MEMORANDUM

DATE: May 10, 2023
TO: Kelly O’Neill Jr. (City of Sandy)
FROM: Todd Prager, RCA #597, ISA Board Certified Master Arborist
RE: Tree Variance Review for Cascade Creek Apartments

This memorandum is a summary of my review of the proposed tree variance for the Cascade Creek Apartments project at 38272 OR-211 in Sandy, Oregon.

C-102
LAND-USE

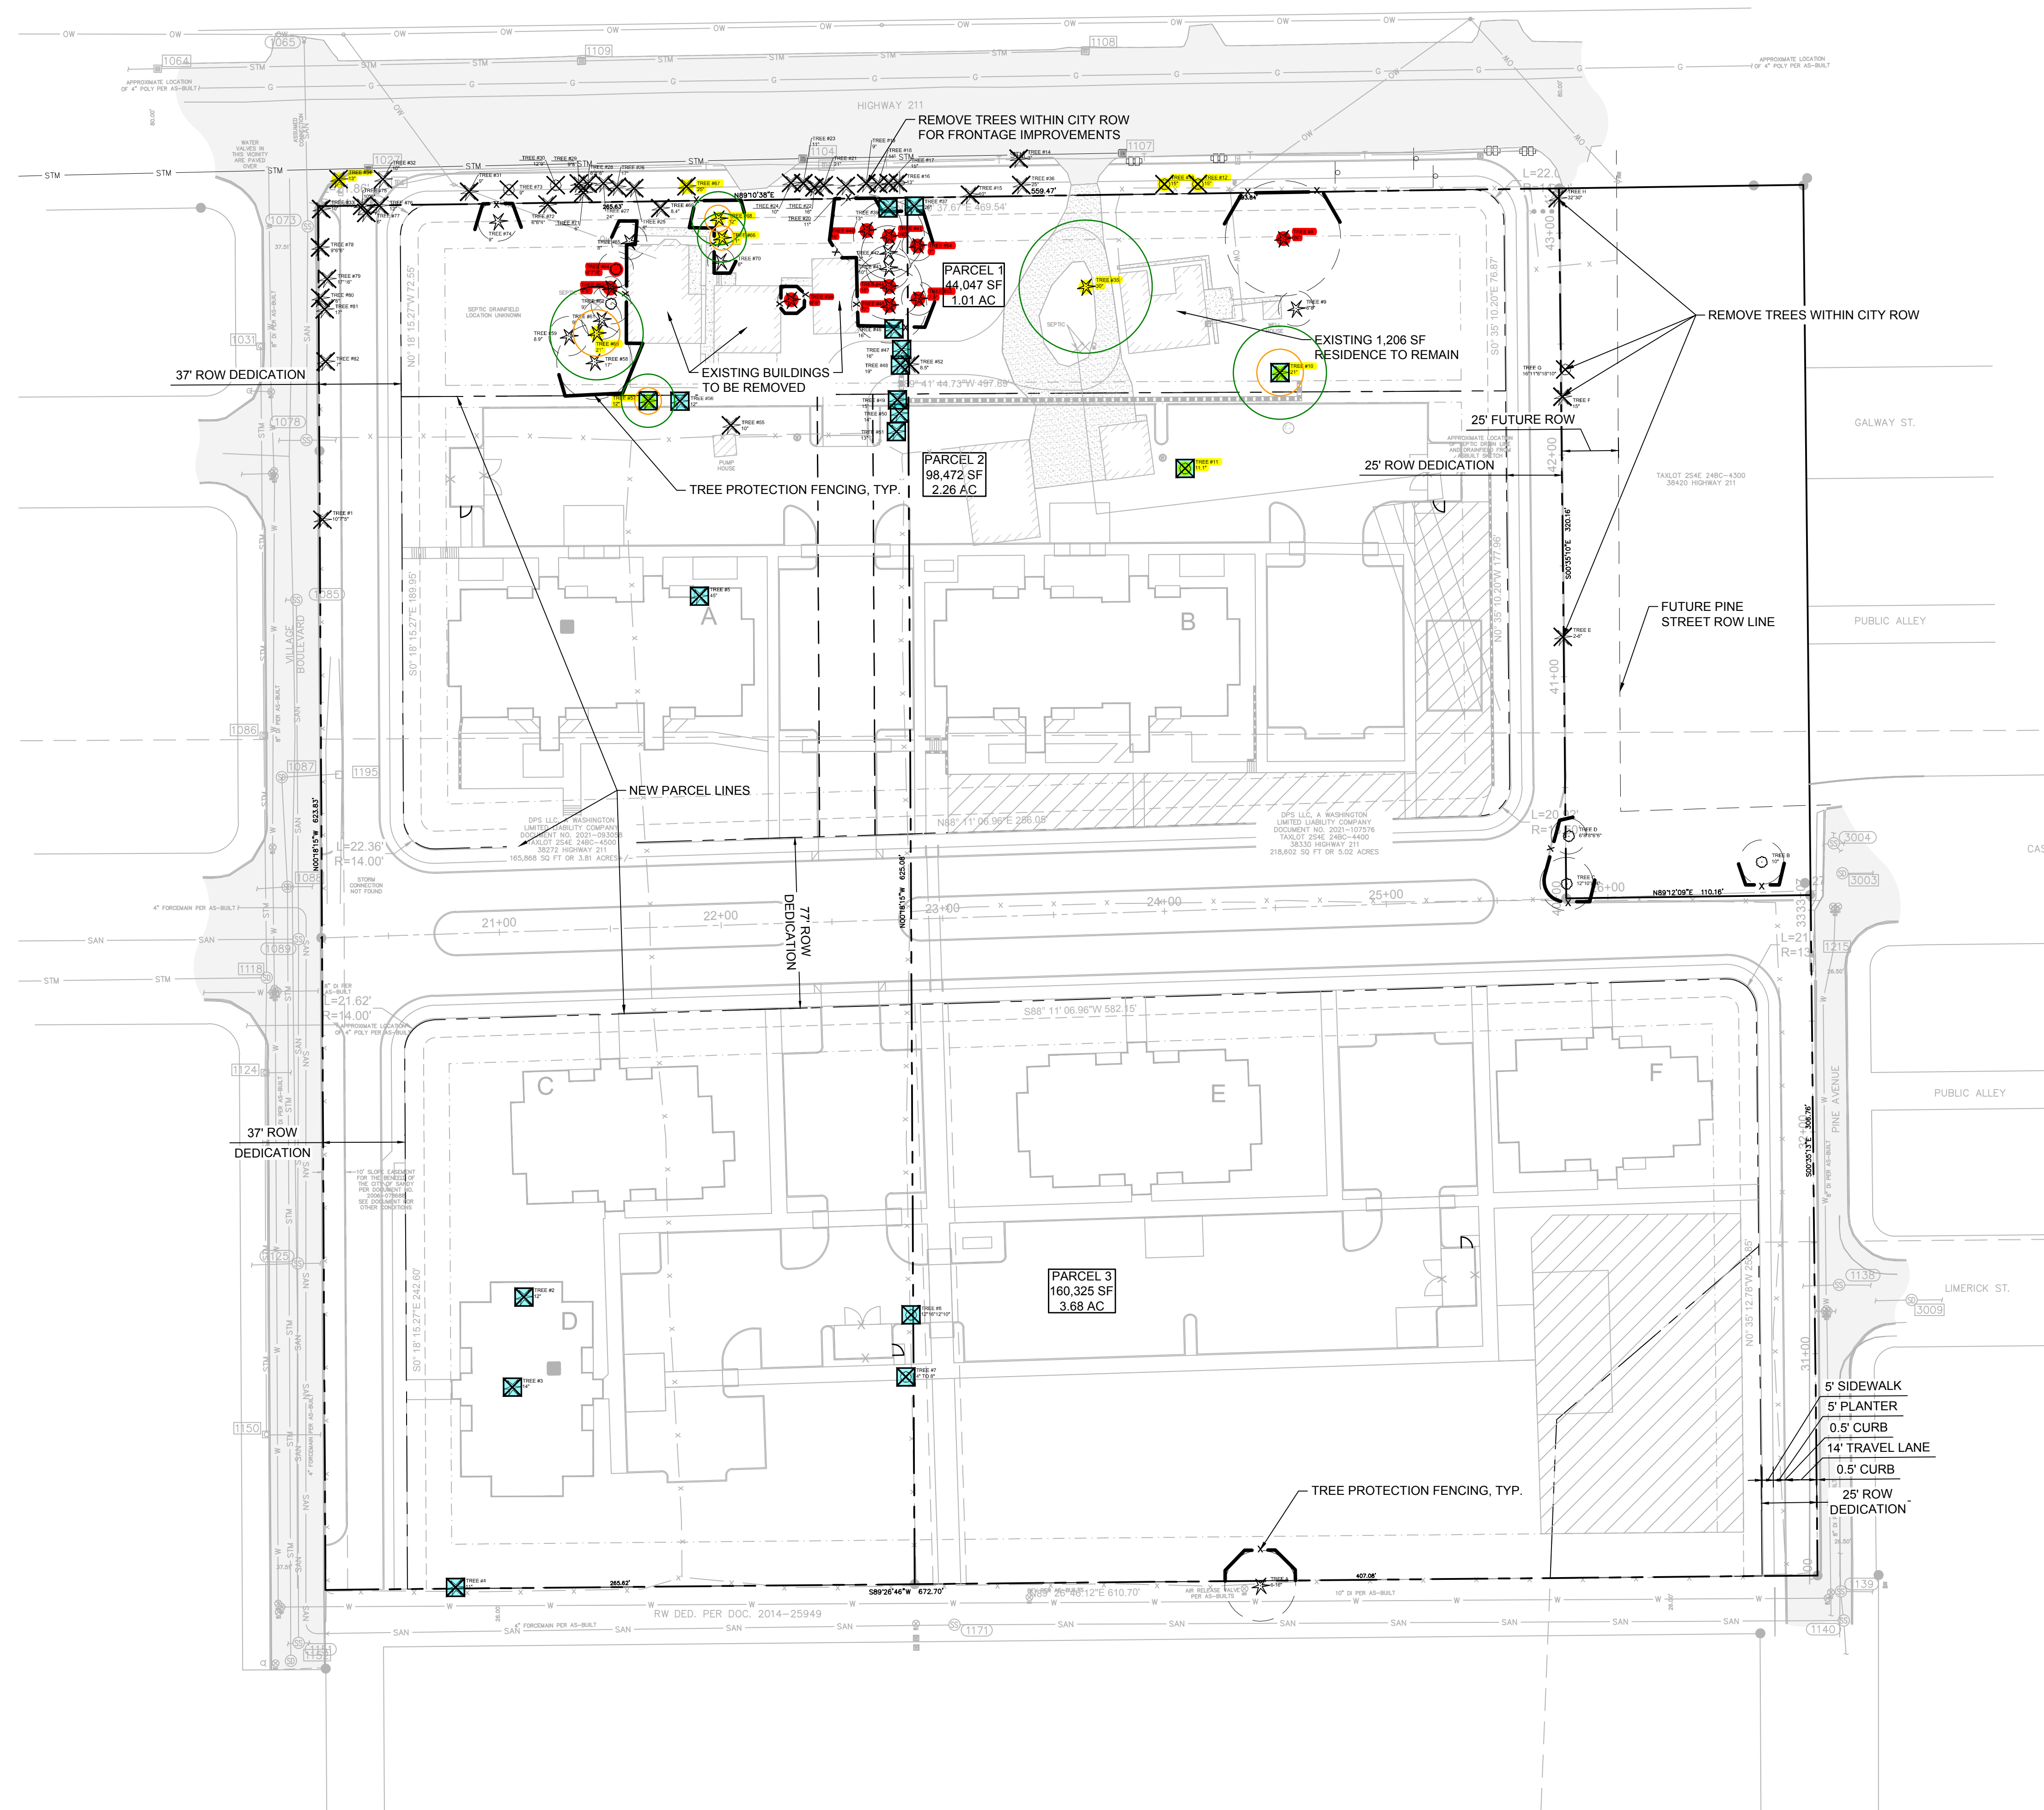
The City of Sandy's administrative practice is to require preservation trees to be in good health condition. In reviewing Table 3 of the arborist report, there are 11 potential preservation trees at the site (trees 10, 11, 12, 13, 34, 35, 57, 60, 66, 67, and 68, which I highlighted in yellow in Attachment 1). Four of these trees (trees 35, 60, 66, and 68) are proposed for preservation while the remaining seven trees will be removed. Of the seven trees proposed for removal, four are not practicable to retain because they are within the footprint of right-of-way improvements along Highway 211 (trees 12, 13, 34, and 67) and one is not practicable to retain because it is near the center of a proposed parking lot (tree 11). Two of the trees may be practicable to retain because they are at the edges of a proposed parking lot (trees 10 and 57). These trees should be further evaluated by the applicant for retention with a modified site design which could include reducing adjacent parking stall depth, eliminating adjacent parking stalls, and/or shifting or adding parking lot islands so they are adjacent to the trees.

Findings and Recommendations: The gross site acreage is 8.83 acres and the BVO standards require the preservation of six trees per acre. Therefore, a total of 53 preservation trees are required to be retained. There are 11 possible preservation trees at the site. Four are proposed for retention, five are not practicable to retain based on their locations relative to right of way and parking lot improvements, and two may be practicable to retain with minor design changes. The applicant should further evaluate design options to retain trees 10 and 57.

Ten of the trees to be retained are currently in poor condition. These trees are highlighted in red in Attachment 1. The applicant team should coordinate with the

Findings and Recommendations: Ten trees to be retained are in poor condition and eligible for removal. The applicant team should coordinate with the project arborist to evaluate whether trees in poor condition should be retained or if they should take the opportunity to remove them with proposed construction.

Tree 35 is proposed to be retained but does not have tree protection fencing shown for its root protection zone. In reviewing sheet C-501 from the civil plan set, there is a new sanitary sewer service line proposed within its root protection zone. Based on the potential impacts to the tree, tree protection fencing should be provided for tree 35. The applicant team should also coordinate with the project arborist to determine if an alternate route for the sanitary sewer service line is possible to better protect the tree.

Findings and Recommendations: Tree 35 does not have tree protection fencing and there is a sanitary sewer service line proposed within its root protection zone. Tree protection fencing should be provided for tree 35. The applicant team should determine if an alternate route for the sanitary sewer service line is possible to better protect the tree.

- Further evaluate design options to retain trees 10 and 57;
- Coordinate with the project arborist to evaluate whether trees in poor condition should be retained;
- Provide protection fencing for tree 35 and determine if an alternate route for the sanitary sewer service line to avoid the tree's root zone is possible;
- Require the project arborist to be onsite and document the proper protection of tree 70 during demolition work in its root zone for it to receive credit as a mitigation tree; and
- Provide 37 to 41 additional native replacement trees and ensure a minimum spacing of at least 15 feet on center for all replacement trees.
